HERDSMAN LAKE - SOUTH EAST SECTOR PROPOSALS

STATE PLANNING COMMISSION

**Report and Recommendations
by the
Environmental Protection Authority**

Bulletin 263 June 1986

FIGURE 2

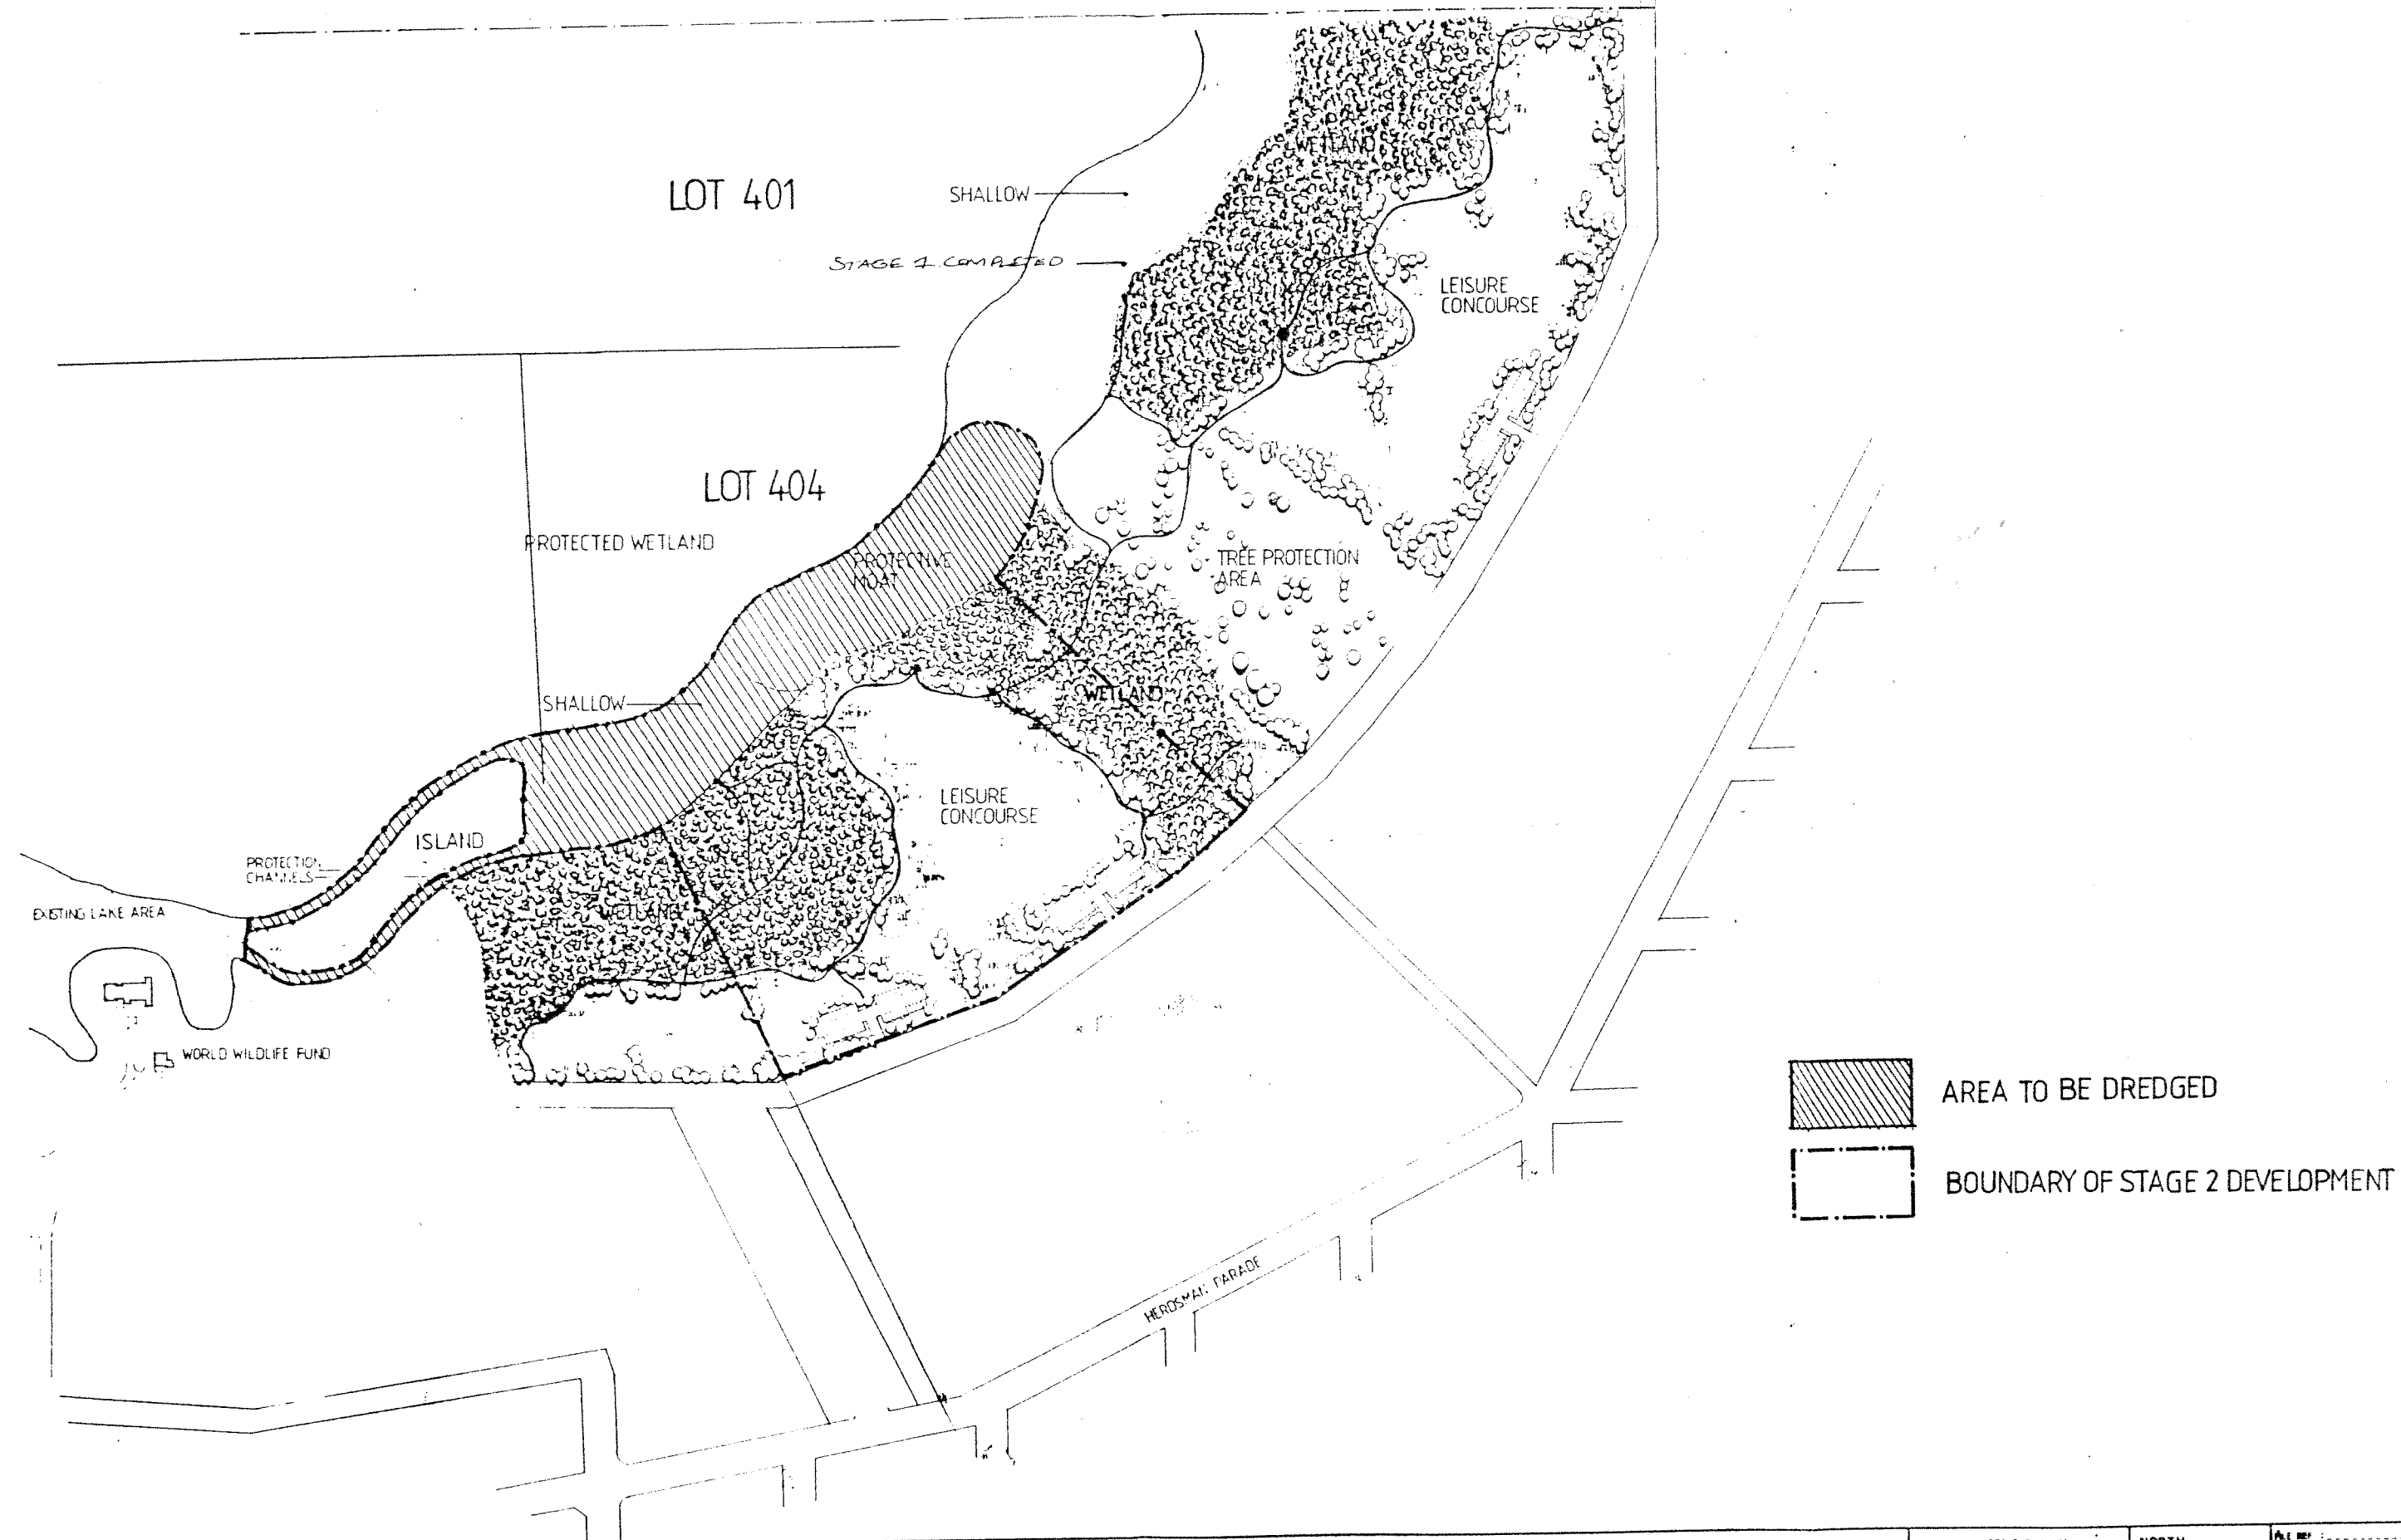
In particular, attempts should be made to increase the amount of shallow mudflats adjacent to the core area and adjacent to reed areas on the outside of the moat.

The Authority believes that the proposed moat should be made as shallow as possible, and in line with its prior advice on stage 1 of the moat in this area, the bed of the moat should not be lower than R L 5.4 metres. The Authority believes that this depth will be adequate to achieve the objectives of a protective moat, whilst providing a desirable additional habitat to the total lake system.

The Authority noted that the moat is to have a peat bottom. This objective is strongly supported and the proponent should ensure that a substantial depth of peat exists on the bottom of the finished moat.

The width of the moat has been questioned, however, as a result of accommodating suggestions from the Department of Conservation and Land Management and including the additional mudflat areas referred to in 3.4, the moat will be narrower than originally proposed.

1. The finished lake bed should be no lower than R L 5.4 metres.
2. A substantial depth of peat should exist on the bottom of the completed moat.
3. State Planning Commission should provide a report to the Authority on completion of the project, detailing any unexpected impacts, problems encountered and the means used to resolve them. In addition, a survey of the newly created moat (and the stage 1 moat) should be provided to show the finished depth does not exceed the depth as per recommendation 1.

5. During construction, shallow mudflat areas on the edge of the moat should be provided (except adjacent to the filled recreation areas) to create a wider diversity of habitats.
